### ADDENDUM 3

سَرُسُوْهُم No:	TES/2024/G-008		
001×0 1/2549	Procurement of Pre-Development Study, Design, Supply and Installation and		
Project:	Maintenance of Pilot Wind Renewable Energy for Manadhoo Island		
مُرِّرُ Issued Date	3 <sup>rd</sup> March 2025		
No. of Pages: -04	3y.3.9 Boq: -00	ترورو Drawings: -00

Package Name: Procurement of Pre-Development Study, Design, Supply and Installation and Maintenance of Pilot Wind Renewable Energy for Manadhoo Island, (Package P-4)

Figure: Concept of SoC and N<sub>c</sub>

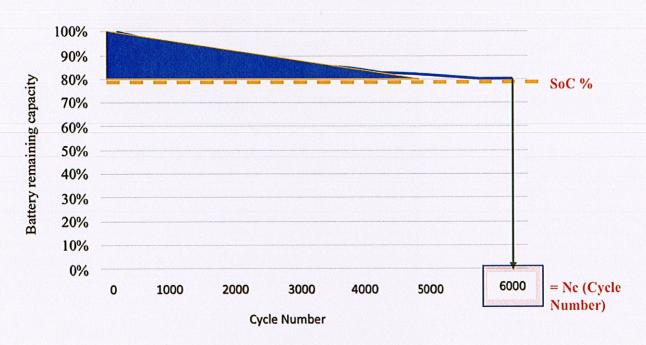
$$LUC_{BESS} = \frac{P_{bid} + N_{br} x P_{BESS}}{C_{BESS} x N_{c} x \frac{SoC}{100}}$$

LUC	[USD/kWh]	Lifecycle unit cost in USD/kWh
CBESS	[kWh]	Overall capacity of BESS specified in specification submitted by the bidder
Nc	[-]	Number of battery cycle tested and guaranteed from the test report with capacity above SoC%
SoC	%	State of Charge, corresponding to remaining usable capacity of battery in % in kWh against initial capacity of battery in kWh, guaranteed after battery is charged and discharged Nc number of times
		Number of times of required battery replacement in 15 years, assuming the battery is fully charged and discharged
Nbr	[-]	once a day. When $Nc > 6000$ times, $Nbr=0$ . When $Nc \le 6000$ , $Nbr = 6000/Nc$
PBESS	[USD]	The total price of "BESS and related equipment" in USD, put by the bidder including cost of Installation of BESS and related equipment and BESS housing
Pbid	[USD]	Total bid price in USD for the BESS

No and SoC shall be evaluated by the test report submitted by the Bidder in Technical Bid.
